Subject: S. 16 Planning Application No. A/YL-KTN/1252 - Departmental Comments

Comments from Transport Department

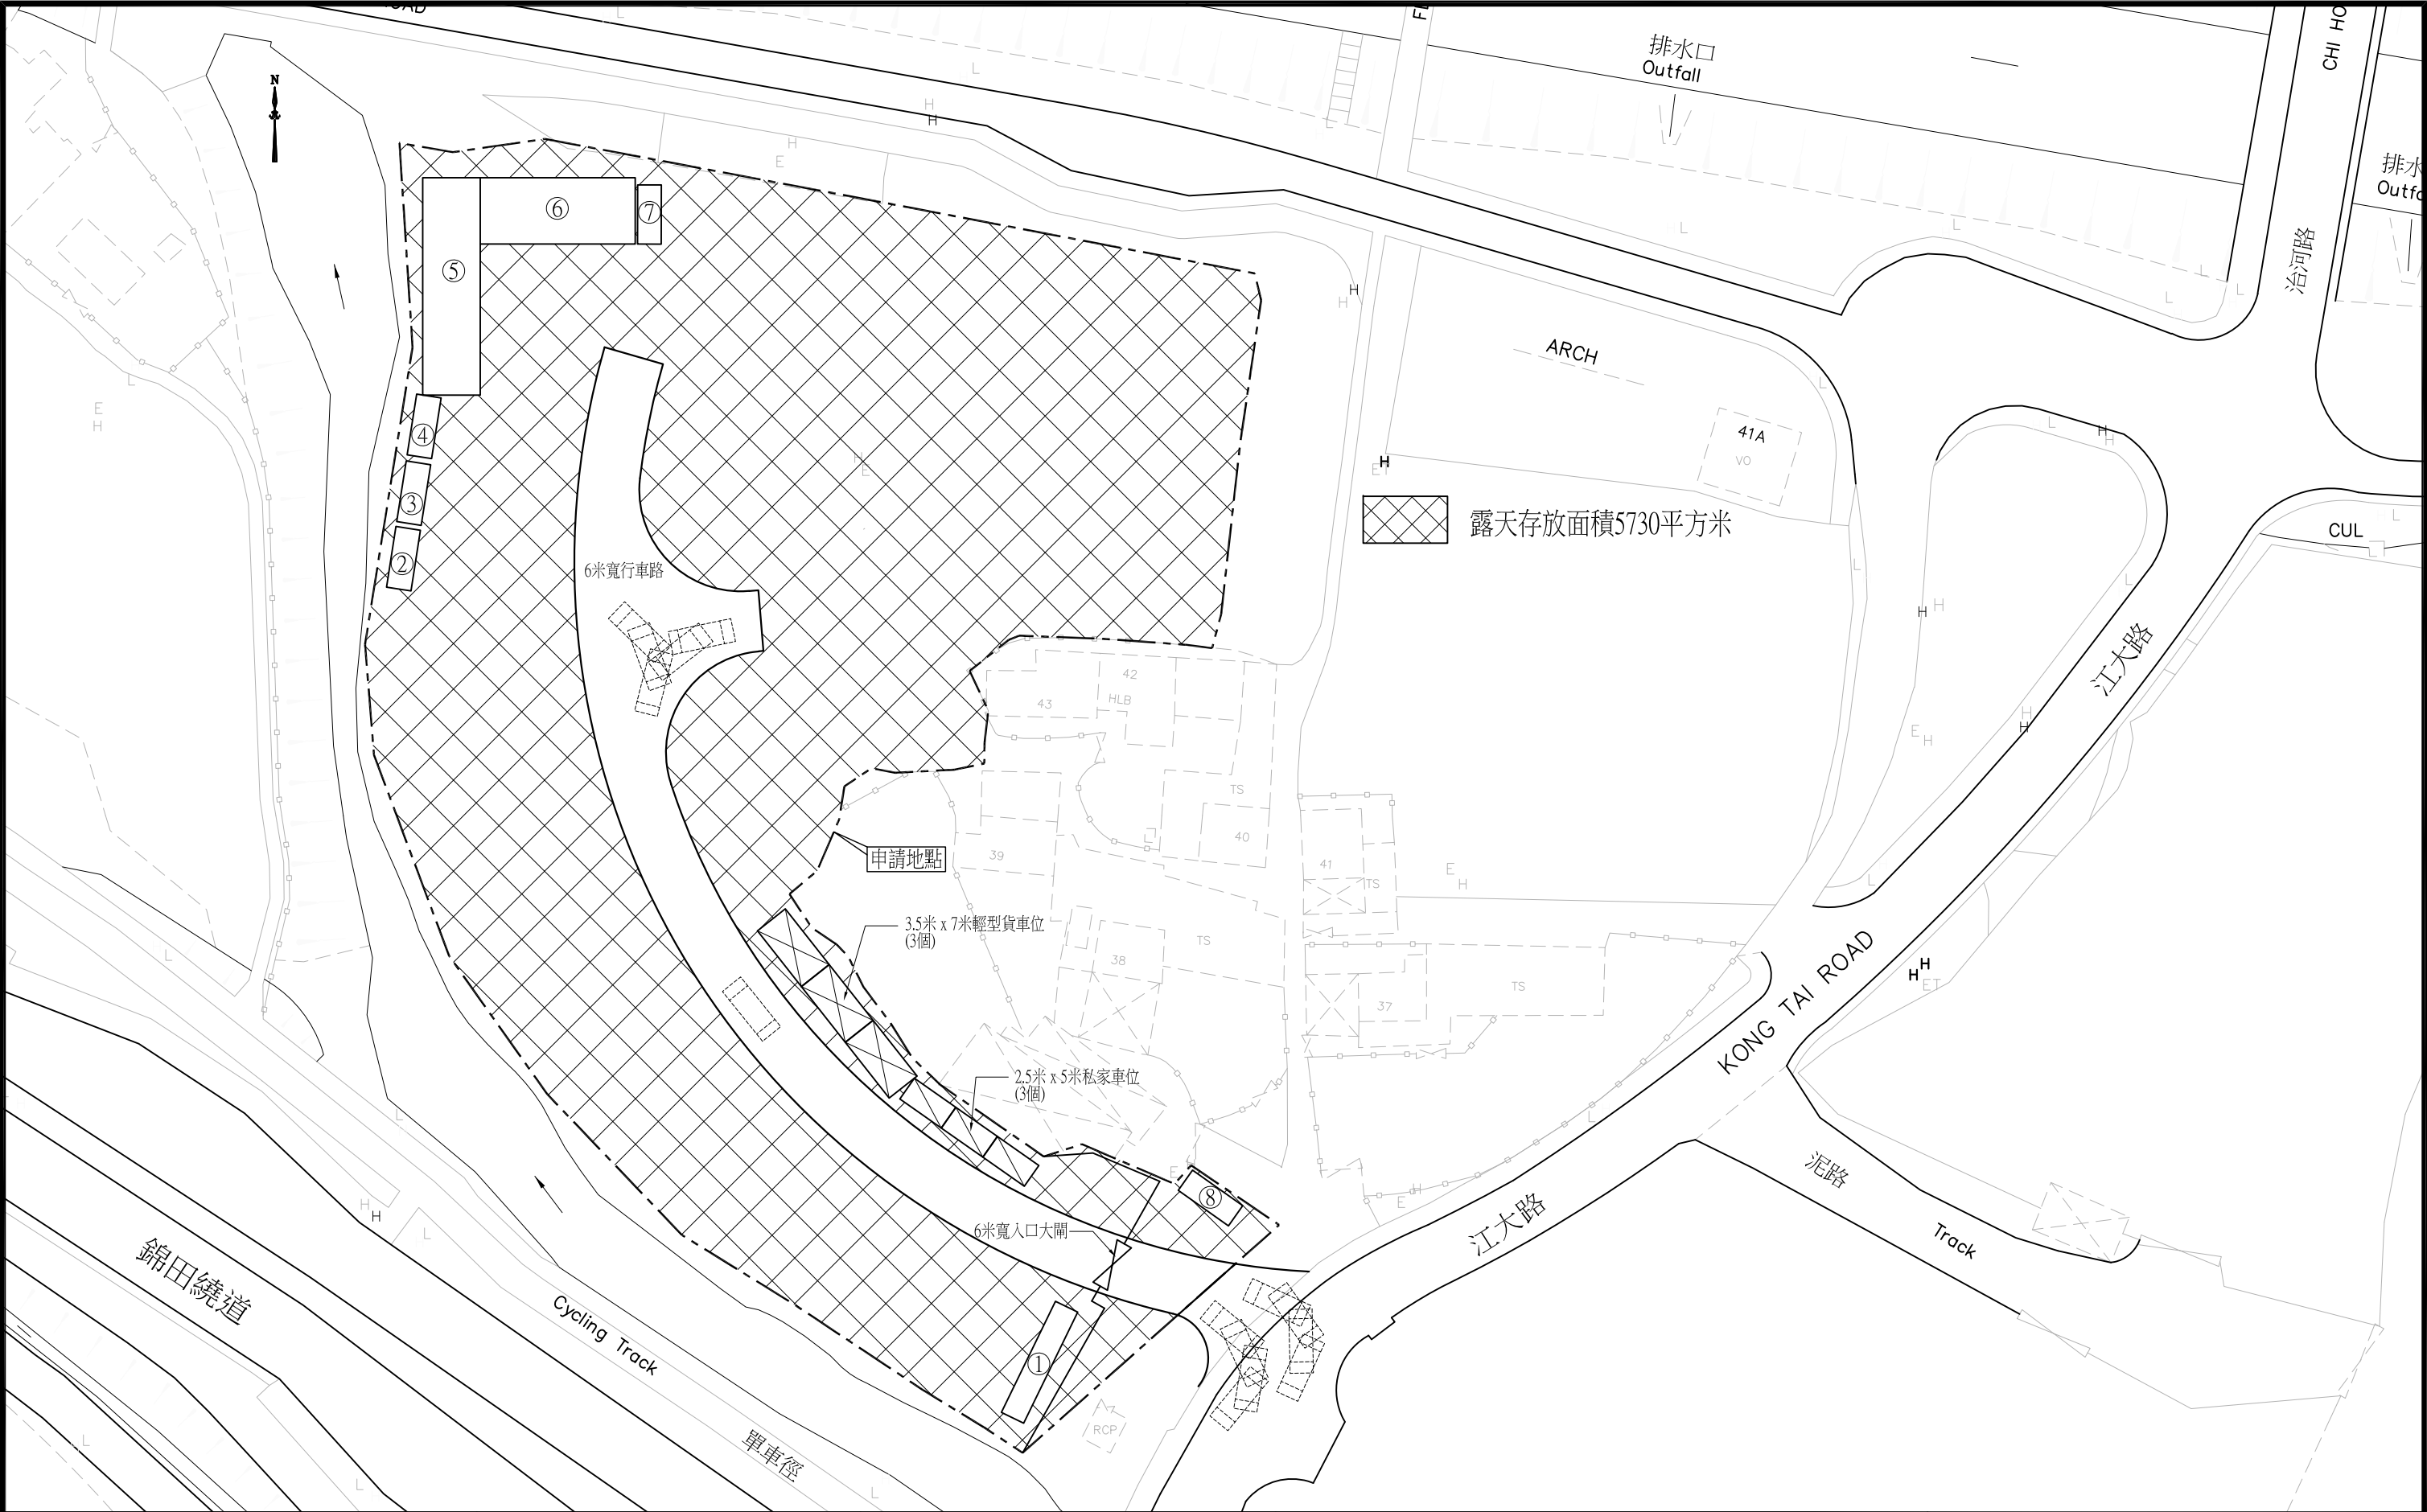
a. The applicant should provide the trip generation and attraction due to the development and assess the traffic impact to Kong Tai Road and the local access;	申請地點的日常運作時間為星期一至六,上午 9:00 至下午 6:00,星期日及公眾假期休息,進出場地的車次量估計(如下圖)以日車輛只有二至三次,申請現場設有私家車位三個,輕型貨車位三個及重型貨上落貨車車三個,故此不會影響接連的江大路。
a. Considering Kong Tai Road is relatively narrow, the applicant should demonstrate the smooth manoeuvring of vehicles to / from Kong Tai Road. The applicant should also provide swept path within the site for the proposed private car and light goods vehicle.	申請人知道有場地直接接連江大路的入口段對拖板車而言是較為狹窄,而申請場地亦不需要用拖板大車送貨,常用的只用 24 噸吊雞車,入口處(見相片)道段,亦可以作通行。
